SUBJECT: Explanation of Significant Differences (ESD)
Operable Unit 2 (OU 2)
Broderick Wood Products Superfund Site

Explanation of Significant Differences
for the
Ground-Water Remedy

**Appendix A
Comments Received
on the Proposed
Explanation of Significant Differences**

Responsiveness Summary to Comments Received on the Proposed Explanation of Significant Differences

FIGURE 9

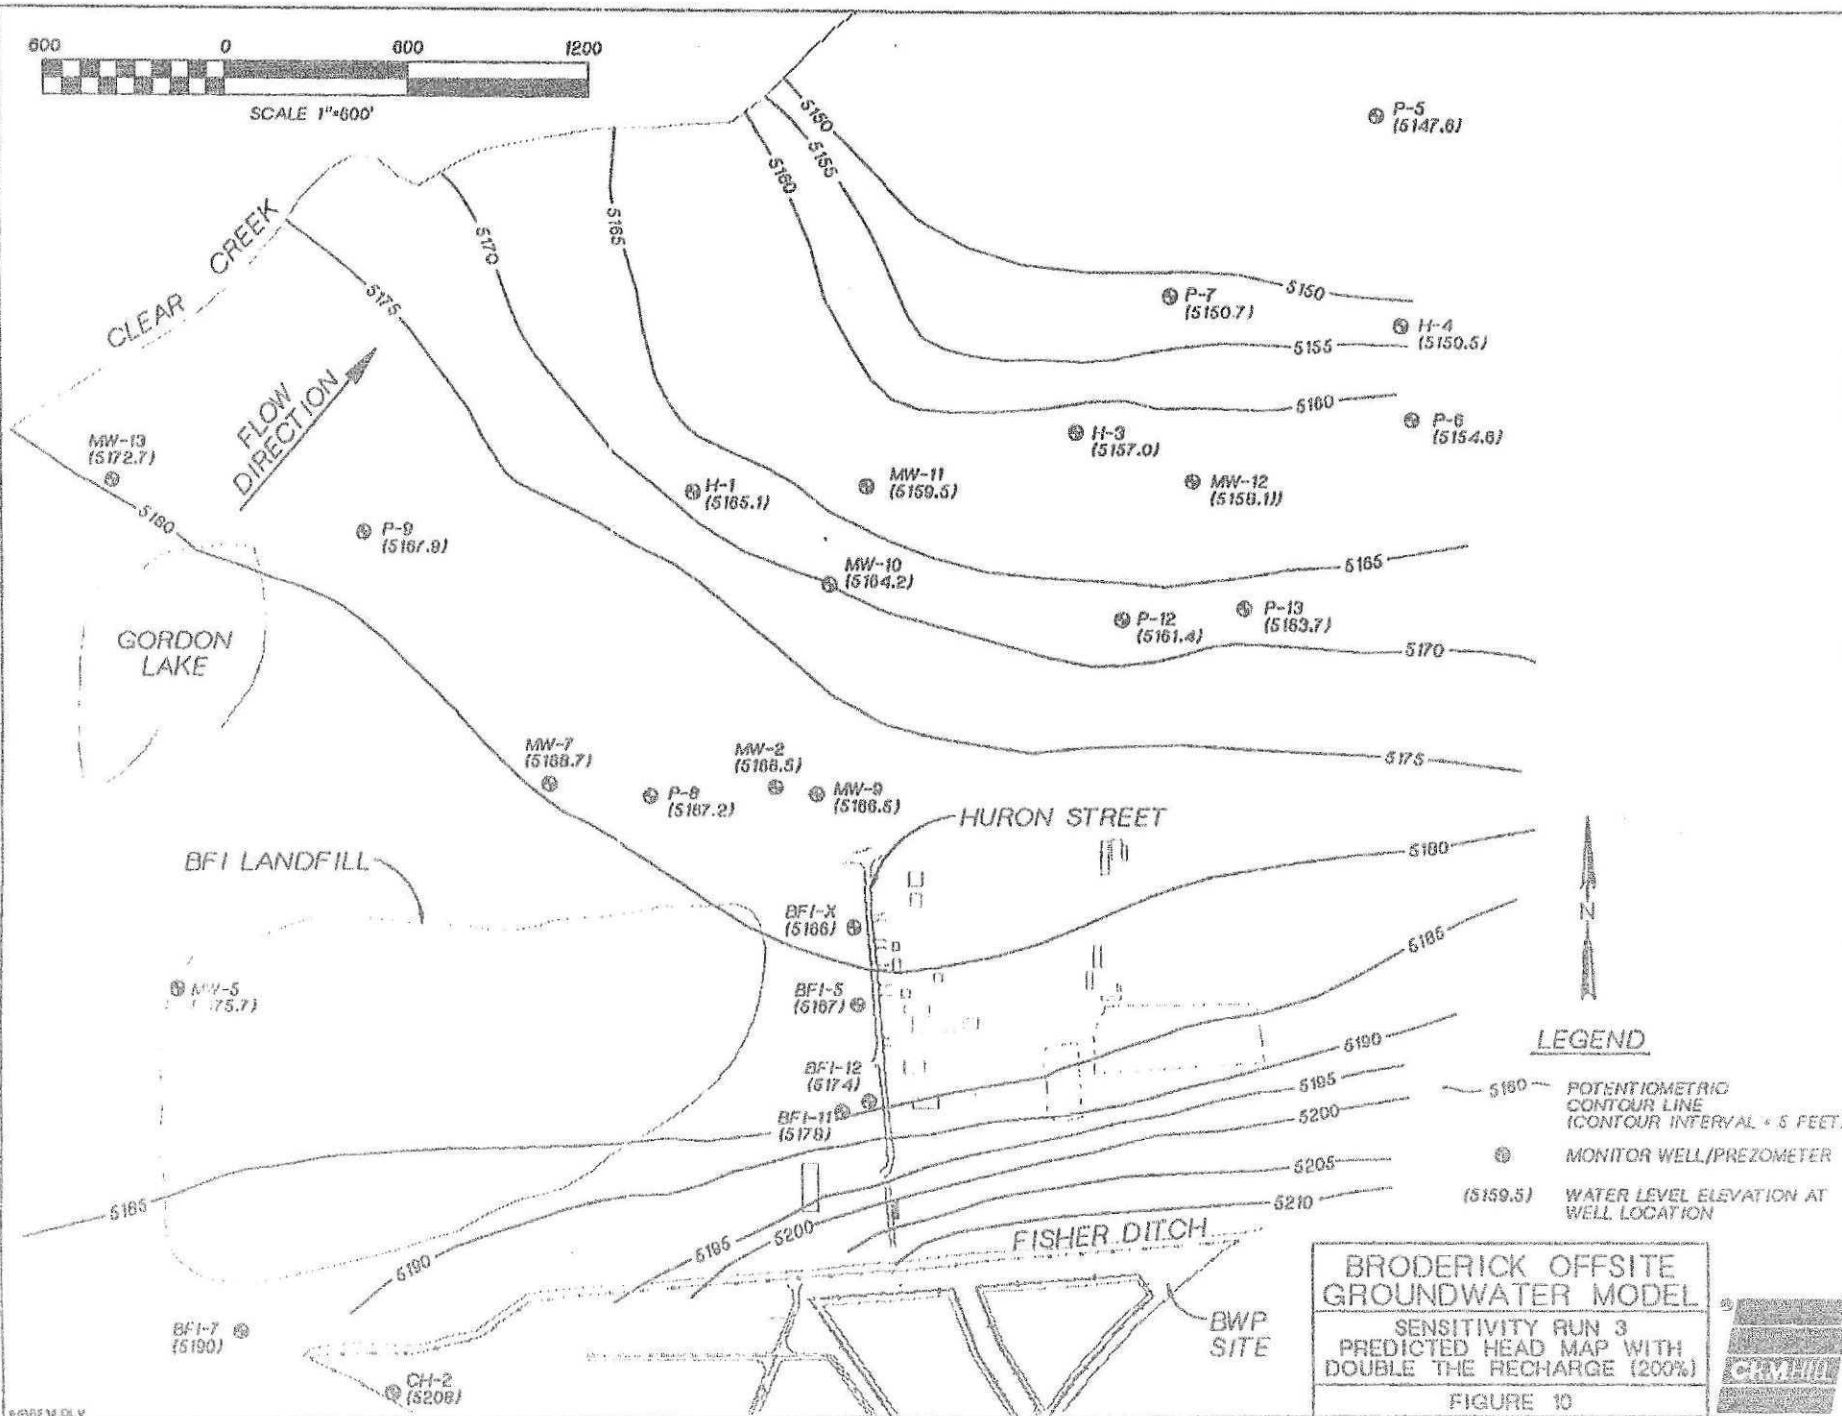
The statement that the model is not sensitive to changes in hydraulic conductivity and recharge is not accurate. For example, comparison of Figure 7 (calibrated) with Figure 9 (twice the hydraulic conductivity) reveals that water levels changed as much as eight to 10 feet in some areas. Therefore, one can conclude that the model is indeed sensitive to changes in hydraulic conductivity. The same comparison can be made for recharge.

The statement that the model is not sensitive to changes in hydraulic conductivity and recharge is not accurate. For example, comparison of Figure 7 (calibrated) with Figure 9 (twice the hydraulic conductivity) reveals that water levels changed as much as eight to 10 feet in some areas. Therefore, one can conclude that the model is indeed sensitive to changes in hydraulic conductivity. The same comparison can be made for recharge.
